ADDENDUM NO. 3

CITY OF MASSILLON, OHIO
WWTP UPGRADE 2000

SK-P22-001

SECTION A
SCALE: 3/16" = 1'-0"

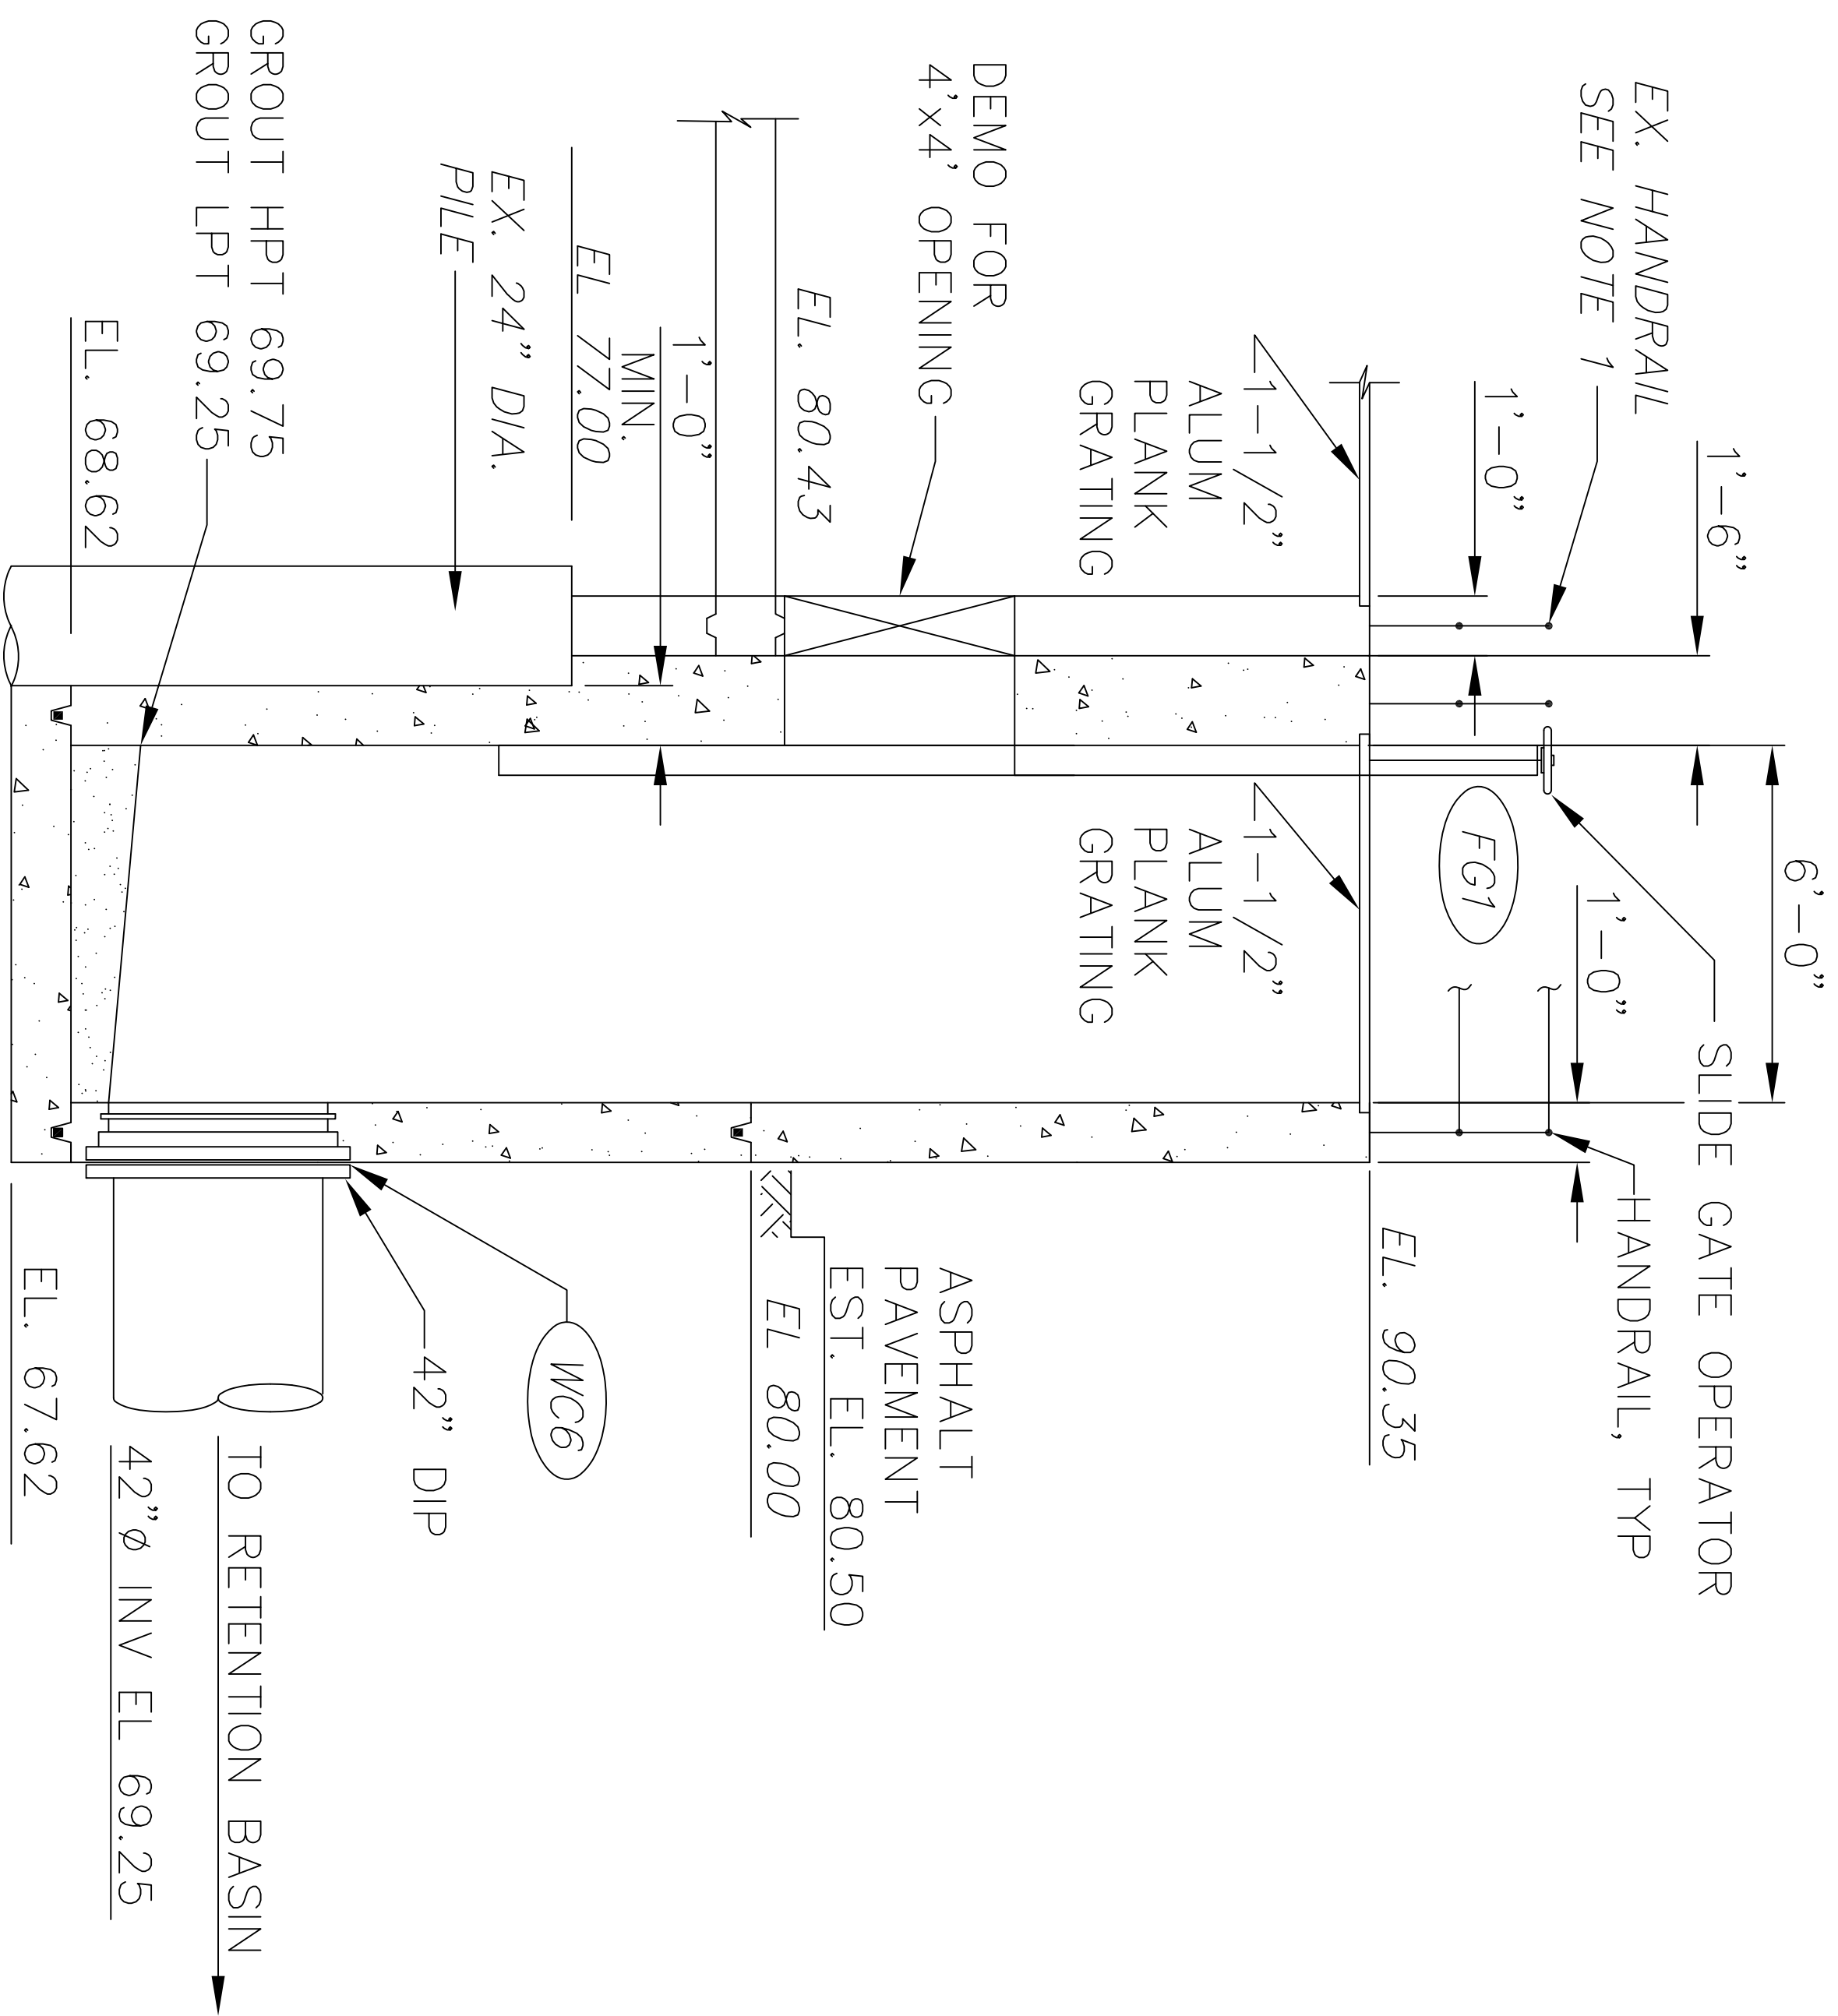
- NOTE: 1. CONTRACTOR SHALL REMOVE EXISTING HANDRAIL AT GRIT TANK CHANNEL ADJACENT TO PROPOSED HANDRAIL, PROVIDE STEEL TERMINATION POST.
2. PROVIDE COMBINATION GATE FRAME FOR FABRICATED GATE.
